# **SUBMISSION RELATING TO DEVELOPMENT APPLICATION FOR 241-249 WHEAT ROAD, COCKLE BAY**

1. This constitutes an objection to the development proposed at 241-249 Wheat Road, Cockle Bay. It is made on behalf of the residents of One Darling Harbour, Pyrmont, who directly face this site.

### **PHOTOMONTAGES FROM THE EIS ILLUSTRATING THE DOMINANCE OF THE TOWER BUILDING OVER THE BRIDGE**

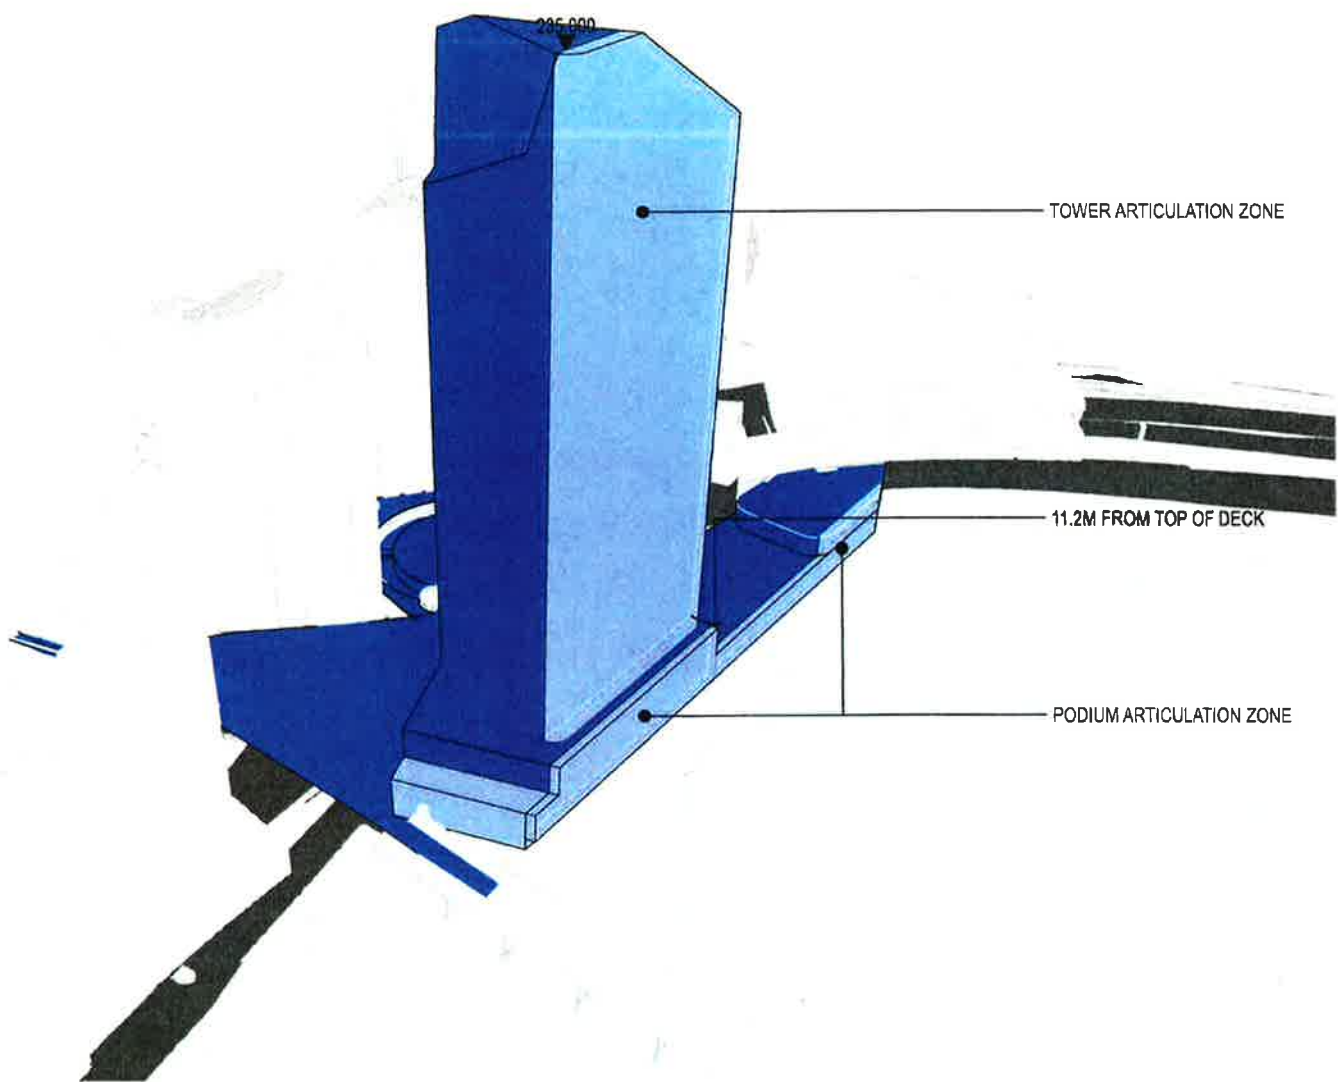
20. Attached as Appendix I are images included in the E.I.S. illustrating the impact of the proposed tower on the context of Pyrmont Bridge. How it can be said that the tower will complement the heritage of the Bridge is difficult to understand.

Building Envelope - 3D View 1

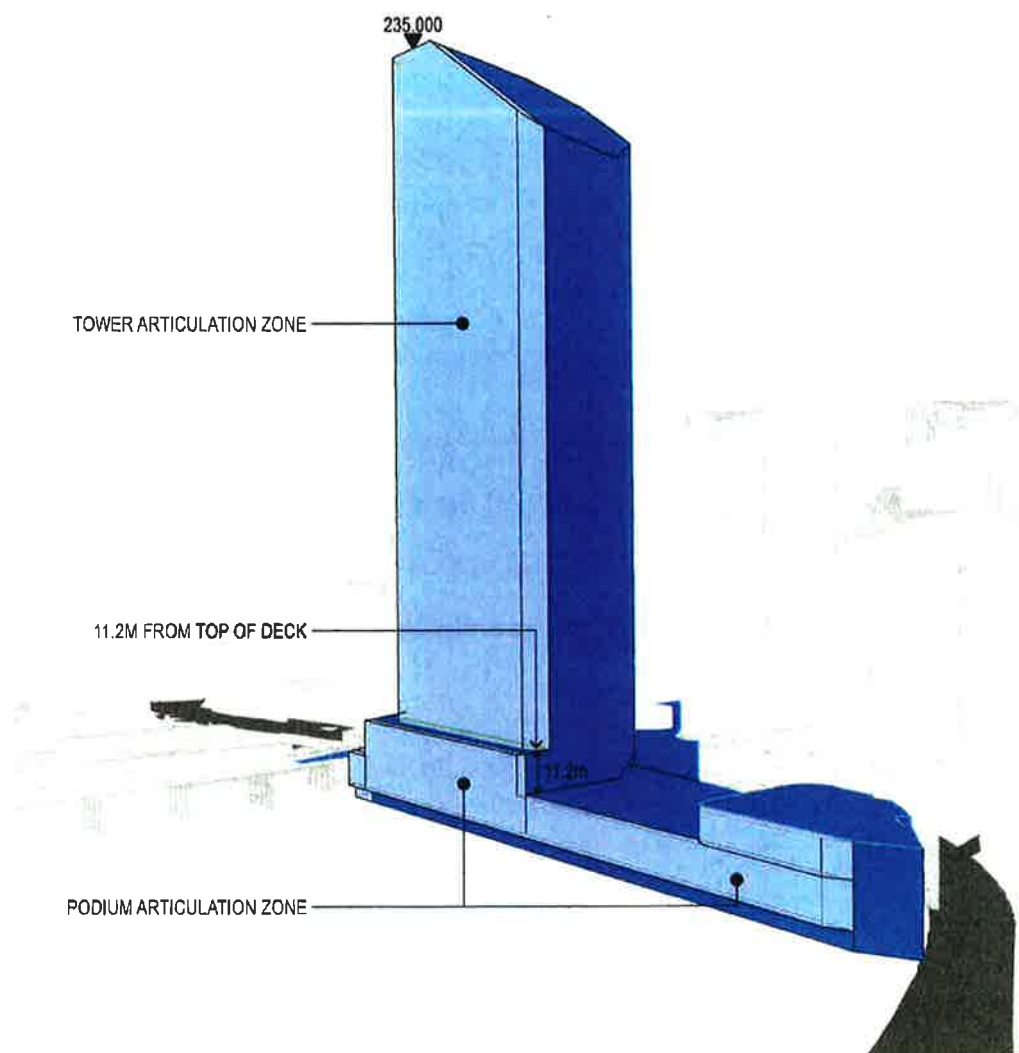
21. Attached as Appendix II are images included in the E.I.S. illustrating the relationship between the tower building and Pyrmont Bridge, together with the relationship with the existing Darling Park buildings and the proximity to the exceptional heritage qualities of Darling Harbour.
